Oakhill College, 423-521 Old Northern Rd, Castle Hill

DA/509/2020 - Objecting Submission - 03/08/20

Figure 12 Landscaper Concept Plan

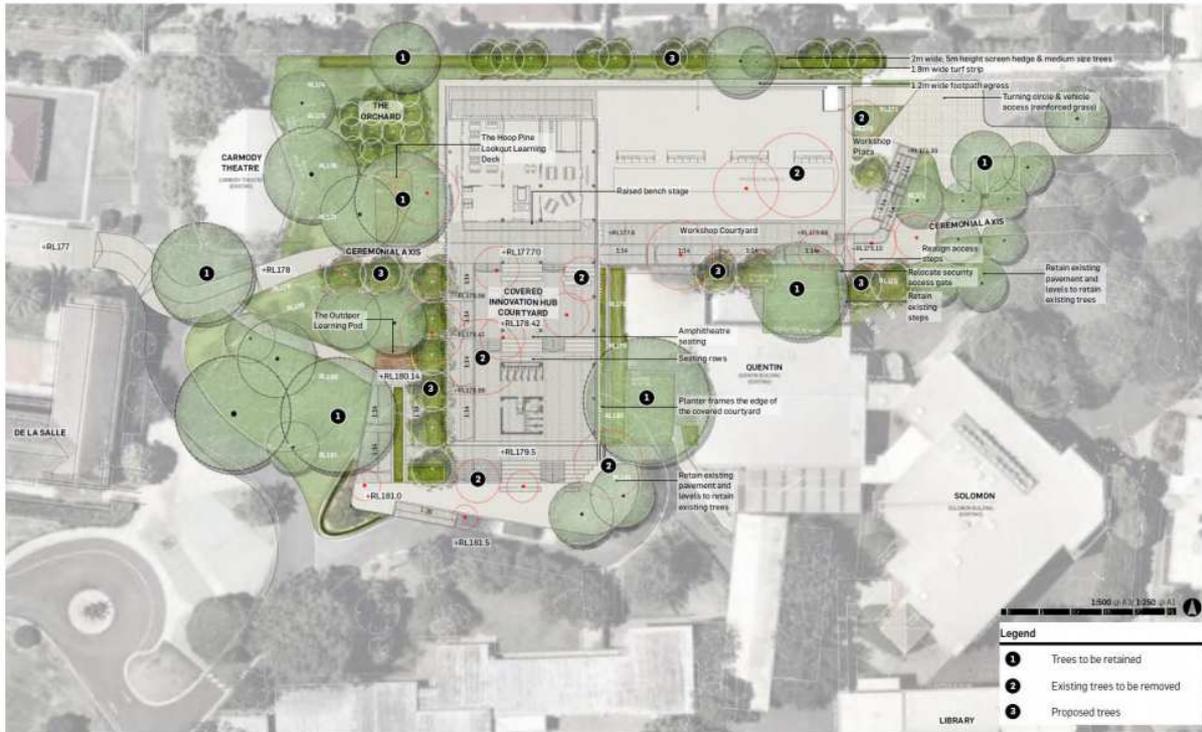
- Furthermore, the Landscape Plan (below) increases the number of trees within the subject site as well as the connectivity of the tree canopy, which is shown to be almost continuous at maturity. **The Landscape Plan is inconsistent with the RFS IPA requirements and must be amended to show the stark open area that it will need to be to meet the IPA requirements.**

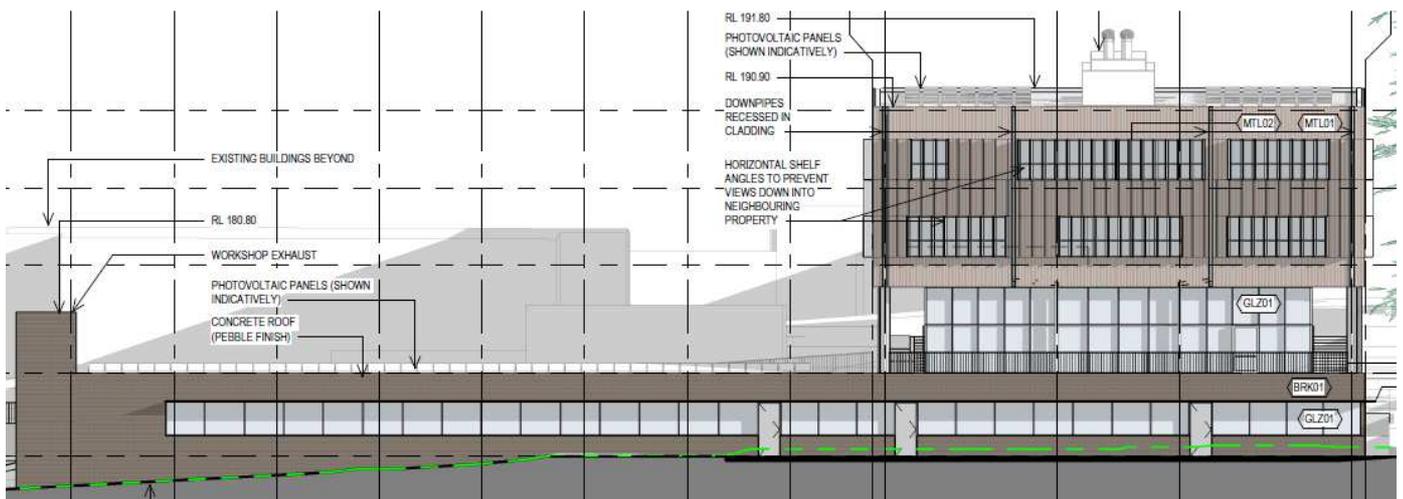
Clause 4.33 of the HLEP 2013 Objective for the height of building development standards is “to permit a height of buildings that is appropriate for the site constraints, development potential and infrastructure capacity of the locality.” The height of the proposed building is inappropriate for the site constraints. The proposed height is 17.291 metres with an indicative roof plant height of over 21 metres. The maximum building height for the site is 8.5 metres. That is a non-compliance of 11.5 metres, not 8.151m as suggested in the applicant's Clause 4.6 Variation.

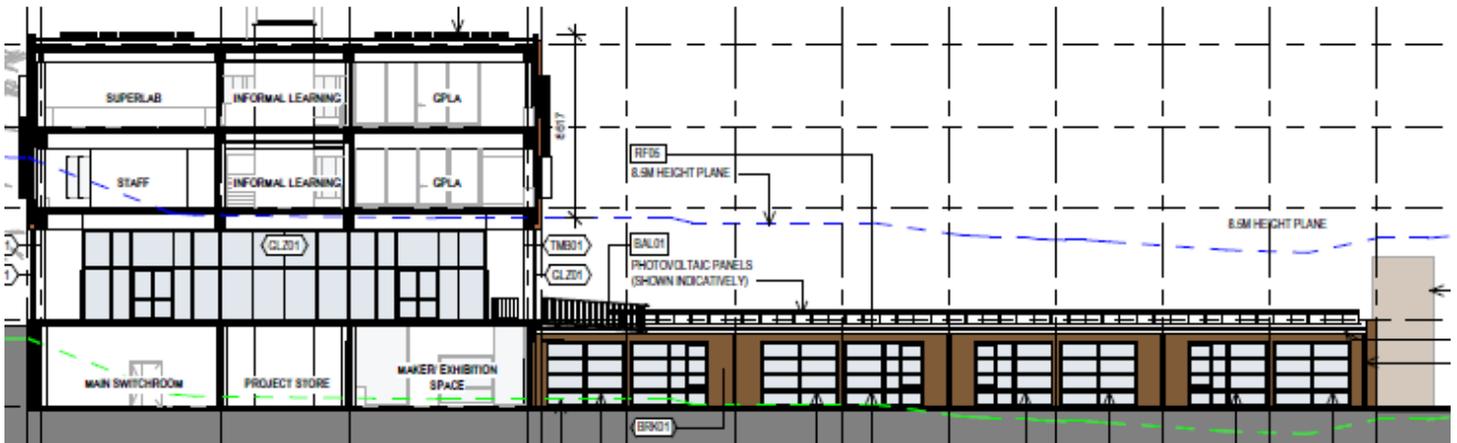
- The Variation states that the "the design has incorporated a stepped design to deliver the required learning space, while aiming to keep the developments footprint low". However the "required learning space" could have been more equally distributed across the two axis, which in itself would have reduced the four storey component by one storey, and the second axis would have still been within the 8.5m height limit.

If even more space was required, that second axis could have been extended further into the carpark to accommodate the "required learning space" of the third storey, bringing the whole L-shaped building within, or close to, the 8.5m height limit. There is more than enough room on the site to have parking elsewhere. Preserving parking in that particular spot should not be considered as a valid reason for not designing a building that is within the height limit.
